# UNITED STATES PATENT AND TRADEMARK OFFICE

APPLICATION NO.	FILING DATE	FIRST NAMED INVENTOR	ATTORNEY DOCKET NO.	CONFIRMATION NO.
10/777,650	02/13/2004	Ma-Li Wang	63349.00002	5617

<b>Office Action Summary</b>	<b>Application No.</b> 10/777,650	<b>Applicant(s)</b> WANG, MA-LI	
	<b>Examiner</b> Jerrold Johnson	<b>Art Unit</b> 3728

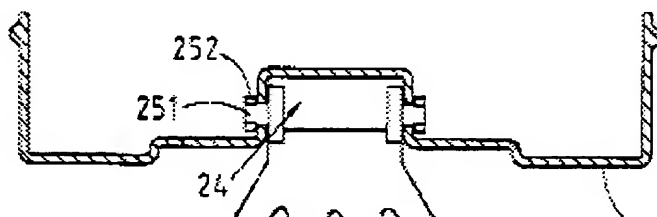
The evidence of the recess in the inclined plane portion is best seen in Figs. 9 -

11. Beginning with Fig. 10, note the dotted line extending from the anchored portion toward the front of the bag. This dotted line would not be shown were there not a surface for which the dotted line is representative. Fig. 9 discloses, rather conclusively, that the surface disclosed by the dotted line of Fig. 10 is the vertical surface separating a recess from the inclined plane portion of the base.

The height of the vertical surface corresponds to the thickness of the support piece. Additionally, the recess shown in Fig. 9 is of a width that corresponds to the width of the support piece, and the dotted lines in Fig. 10 are also of the same shape as to correspond to the support piece. This vertical surface is not shown in Fig. 11, as it would be covered by the support piece.
